From: Price, Wayne, EMNRD **Sent:** Mon 9/26/2005 10:30 AM
To: Monzeglio, Hope, NMENV; James Romero; Foust, Denny, EMNRD; eriege@giant.com
Cc: Cobrain, Dave, NMENV
Subject: RE: New Monitoring well GWM 2
Attachments:

From: James Romero [<mailto:jromero@giant.com>]
Sent: Mon 9/26/2005 9:27 AM
To: Monzeglio, Hope, NMENV; Foust, Denny, EMNRD; Price, Wayne, EMNRD
Subject: New Monitoring well GWM 2

From: James Romero [jromero@giant.com] **Sent:** Tue 9/20/2005 11:40 AM
To: Monzeglio, Hope, NMENV; Price, Wayne, EMNRD; Foust, Denny, EMNRD; Cobrain, Dave, NMENV; Price, Wayne, EMNRD
Cc: Steve Morris; Ed Riege; Johnny Sanchez
Subject: Proposal for new monitoring wells (GWM-2 and GWM-3)
Attachments:  gmw2and3locations.pdf(26KB)  cinizagmwells.DOC(45KB)

Re: Installation Procedures for GMW-2 and GMW-3
Ciniza, New Mexico

New Wells

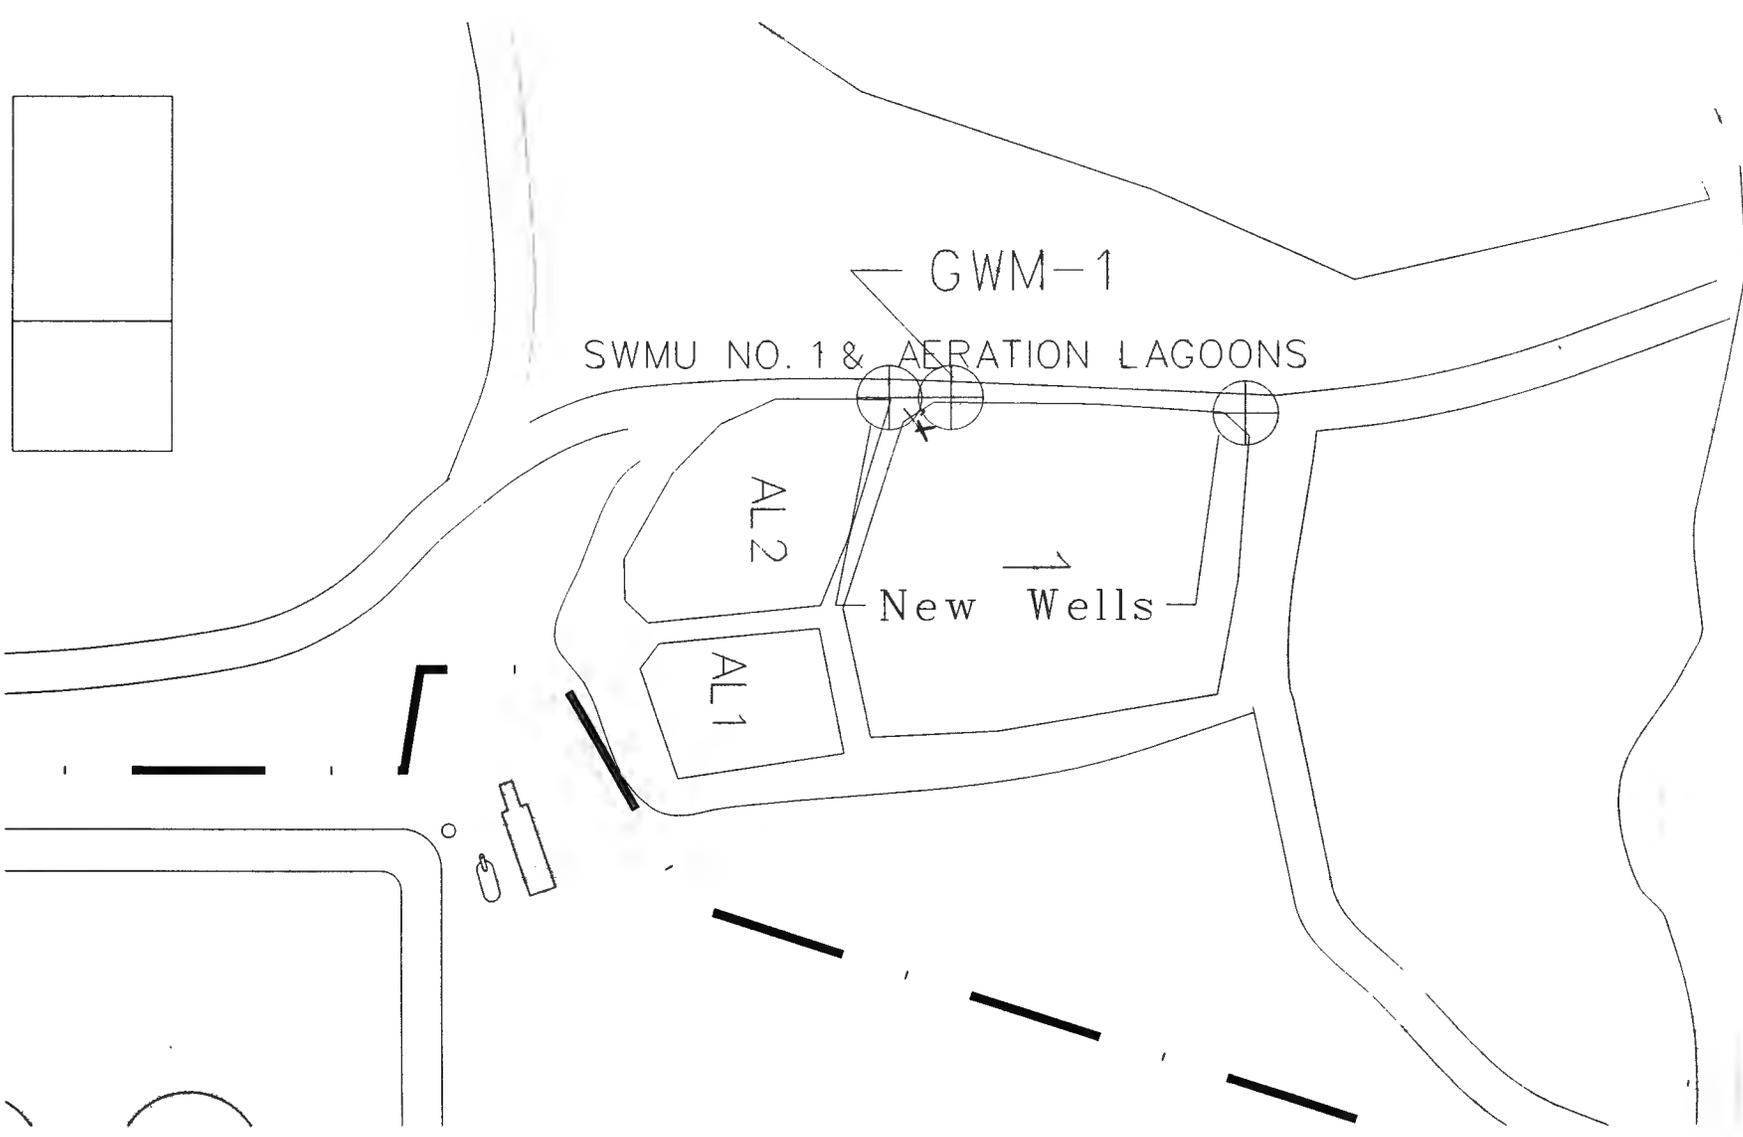
NMED approves the location of GWM-2. Giant must indicate how far below the base of the evaporation ponds GWM-2 was drilled (and GWM-3 upon completion). Giant must submit a revised map providing the new location of GWM-2. Upon completion of GWM-2 and GWM-3, these wells must be checked for fluids on a monthly basis until the new year 2006 and can then be incorporated into the groundwater monitoring plan.

Attached is a picture of the new GWM-2 well which was installed over the weekend. This well is approximately 17' deep with 15' of screen and is dry. The well was moved closer to GWM-1 due to safety and access issues which were raised by our safety officer. I would like to get your approval of this well location asap since we still have precision onsite. <<Picture 042.jpg>>

NMED hereby approves the well and boring installation procedures as presented in the attachments to this email.
